STRUCTURAL EVALUATION OF  
PINOLE MIDDLE SCHOOL  
WEST CONTRA COSTA UNIFIED SCHOOL DISTRICT  
(WCCUSD)

WLC Architects  
Kaiser Building  
1300 Potrero Avenue  
Richmond, CA 94804

DASSE Design, Inc.  
33 New Montgomery Street #850  
San Francisco, CA 94105  
(415) 243-8400

October 17, 2002  
DASSE Design Project No. 01B300x2

Figure 10: Classroom Bldg. Exterior Wall with window openings

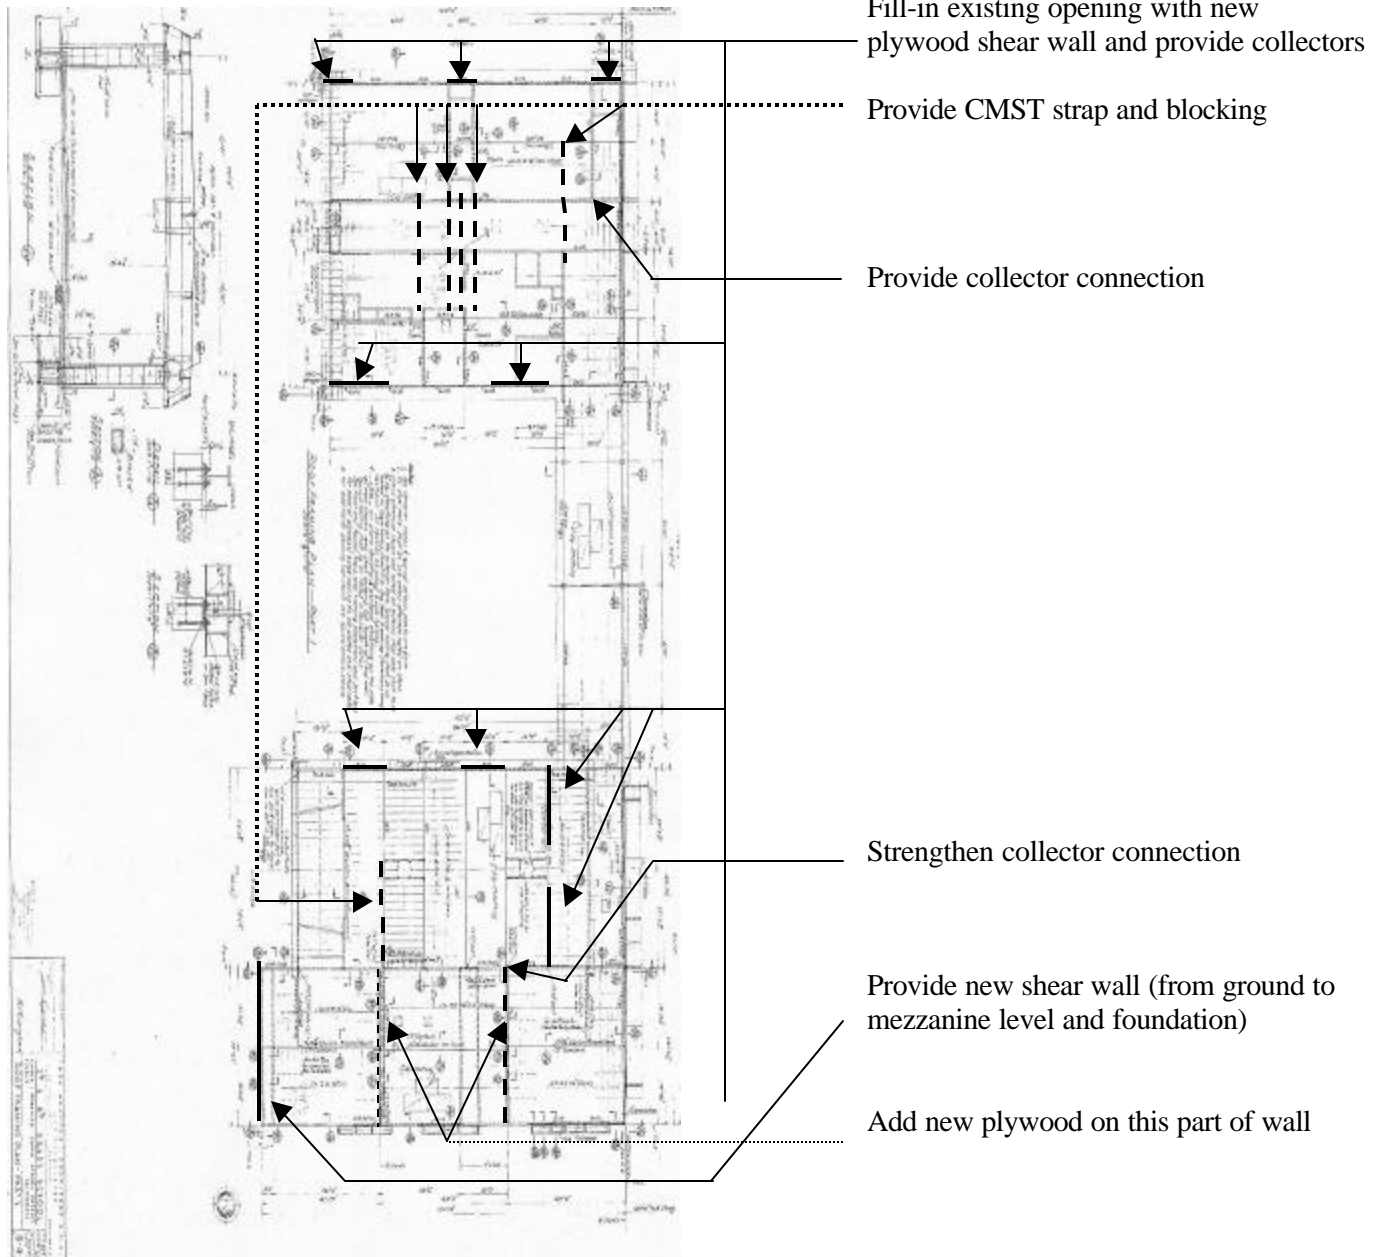
The main building is a one story wood structure (see figures 2). The building exterior typically has a stucco finish. The covered walkways have a plaster finish at ceilings and are connected at their ends to the main buildings. The west face of the administration building has multiple large window openings. The exterior longitudinal walls of classroom buildings (room numbers 1, 2, 3, 5, 7, 9, 11 to 20) have number of window openings (see figure 4).

The lateral system of the classroom wing consists of 1/2” plywood roof sheathing, which acts as a horizontal diaphragm to transfer the seismic loads to 2x6 stud walls acting as shear walls. In the longitudinal direction, the exterior walls have numerous window openings and hence are not adequate shear walls to resist prescribed seismic loads, which poses a life safety hazard. The interior longitudinal corridor walls, with 3/8” plywood sheathing, act as shear walls resisting the lateral forces in the longitudinal (north-south) direction. In the transverse direction, the seismic forces are resisted by transverse shear walls, which have 3/8” plywood sheathing on them. Collector elements to drag the seismic forces to the transverse shear walls are missing and should be provided.

Item	Building Structural Deficiencies
1.	Plywood shear walls at east face of classroom wings (longitudinal walls) lack

adequate shear strength to resist the prescribed seismic forces
2.	Plywood shear walls at west face of classroom wings (longitudinal walls) rooms lack adequate shear strength to resist the prescribed seismic forces

Item	Recommended Remediation	Priority	Drawing Number
1.	Fill-in existing window openings with new plywood sheathing as shown in Drawing 1. Provide new collectors as required.	1.1	1 & 2
2.	Fill-in existing window openings with new plywood sheathing as shown in Drawing 1. Provide new collectors as required.	1.1	1 & 2
3.	Add new plywood sheathing on the other face of shear wall (making it a shear wall with plywood sheathing on both faces of wall)	1.1	1
4.	Fill-in existing window openings with new plywood sheathing as shown in Drawing 1. Provide new collectors as required	1.1	1
5.	Fill-in existing window openings with new plywood sheathing as shown in Drawing 1.	1.1	1
6.	Provide new plywood shear wall (from ground to Mezzanine	1.0	1

Figure 11: East Wall of Multi-Purpose Room

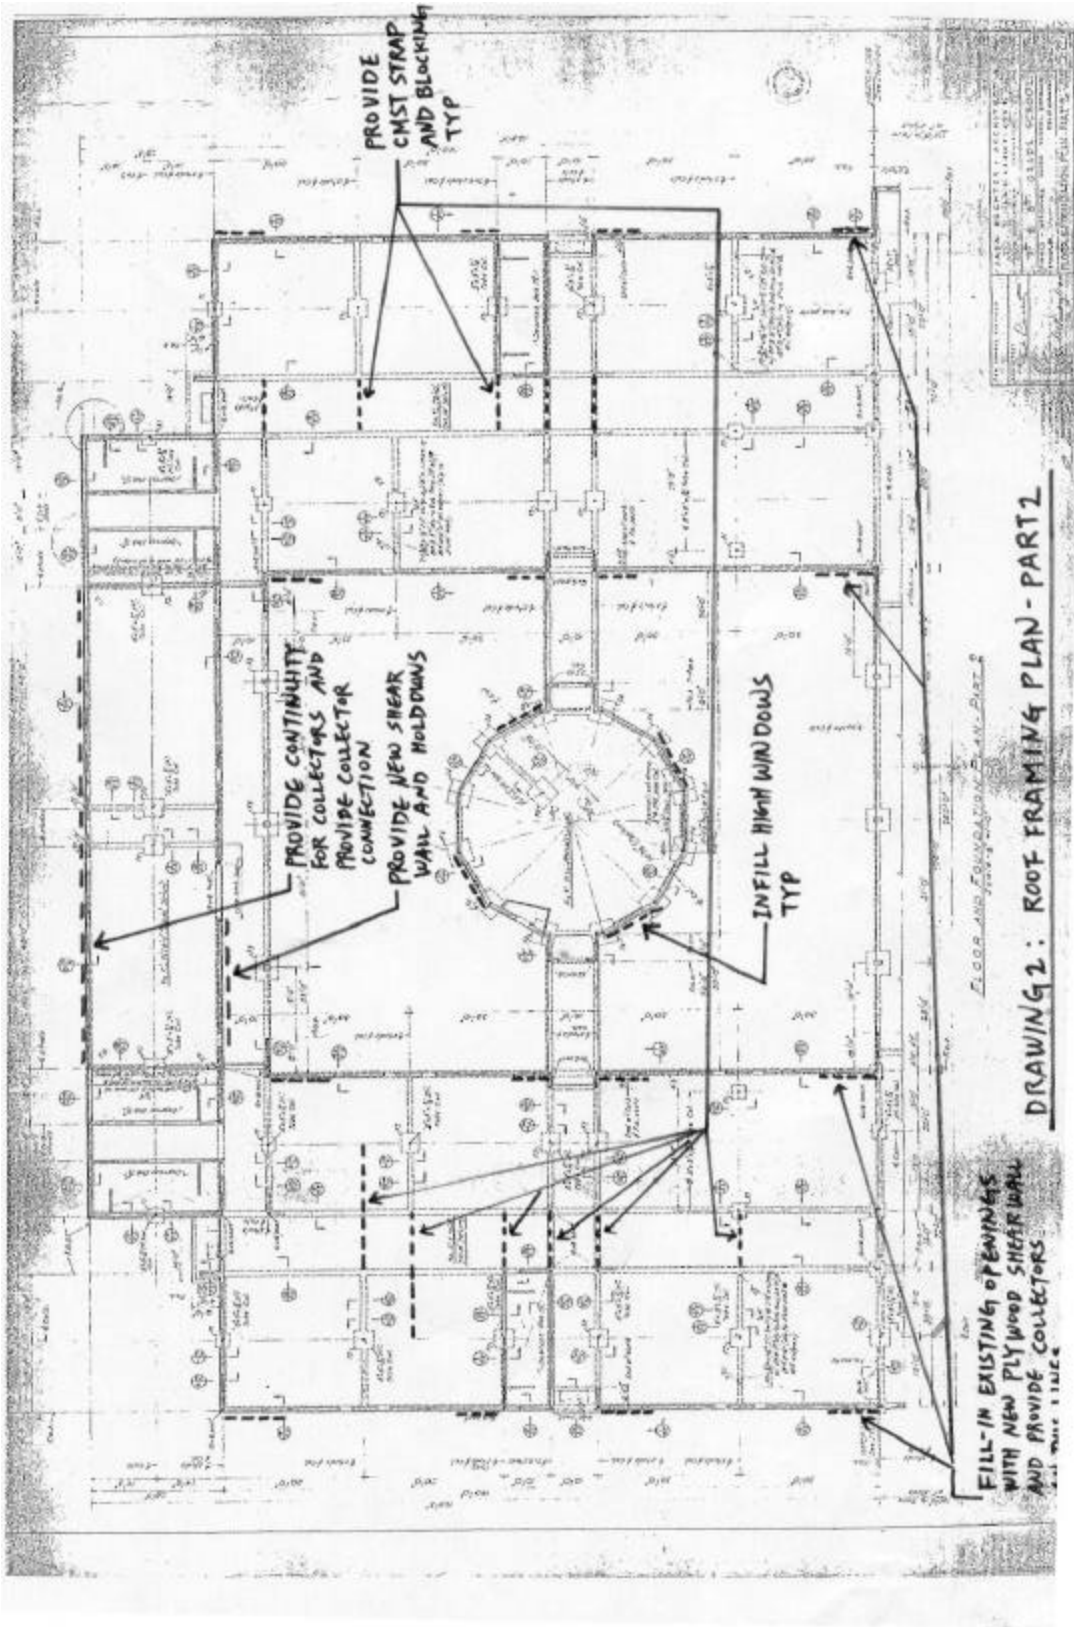
The Multi-Purpose Building has tapered glu-lam beams and wood posts. The east wall of the multi-purpose building has many window openings.

between the multi-purpose room and the music/shop rooms has few door and window openings and has 1/2" plywood sheathing on one side. Holdowns have been provided at some door openings. The south wall and the east wall of the multi-purpose room consist of 2x8 stud walls at 16" centers with a 3/8" plywood sheathing. These walls have excessive door openings and do not have adequate length of shear wall to resist seismic loads.

4.	Plywood shear walls at east face of multi-purpose room lack adequate shear strength to resist the prescribed seismic forces.
5.	Plywood shear walls at south face of Multi-Purpose Room lack adequate shear strength to resist the prescribed seismic forces
